N6745B-01

S E R V I C E N O T E

N6745B 100W DC Power Module

Current Measurement accuracy is out of specification when there is voltage being sourced at the output terminals.

Location of C36 and C37

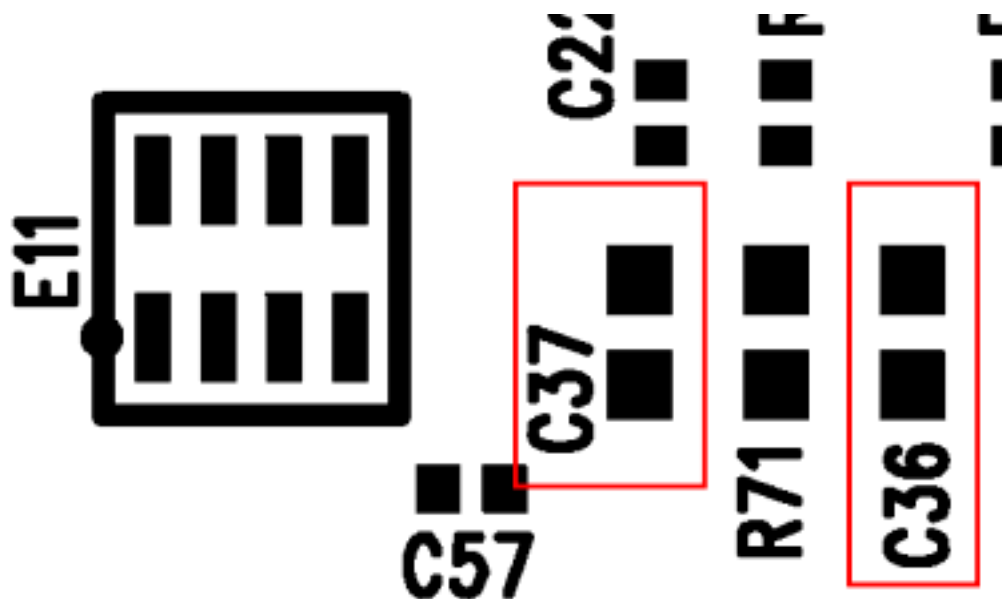
Due to some noise filtering issues, the current measurement accuracy will be out of specification by a fixed offset when there is a voltage being sourced at the output terminals. If the output is shorted, the current measurement accuracy will be within specifications. Please note that the performance verification test will not catch this.

If this measurement is out of specification, replace capacitors C36 and C37 on the DPM assembly (this is the assembly that is vertically mounted in the unit that looks similar to a PC memory module) with part number 0160-7809. After the capacitors are changed, the unit will require re-calibration. After the capacitors are replaced, check the make sure that the unit is in specification by applying 75% of the full voltage range while attached to a load drawing 50 mA to 70 mA. If the current measurement is within the specification, then the unit has been repaired.

Test to see if the module is out of specification by applying 75% of full scale voltage while drawing 50 to 70 mA . Compare the reading to what it should be via the current measurement accuracy spec. If the current measurement is within specification then the capacitors will not need to be changed.
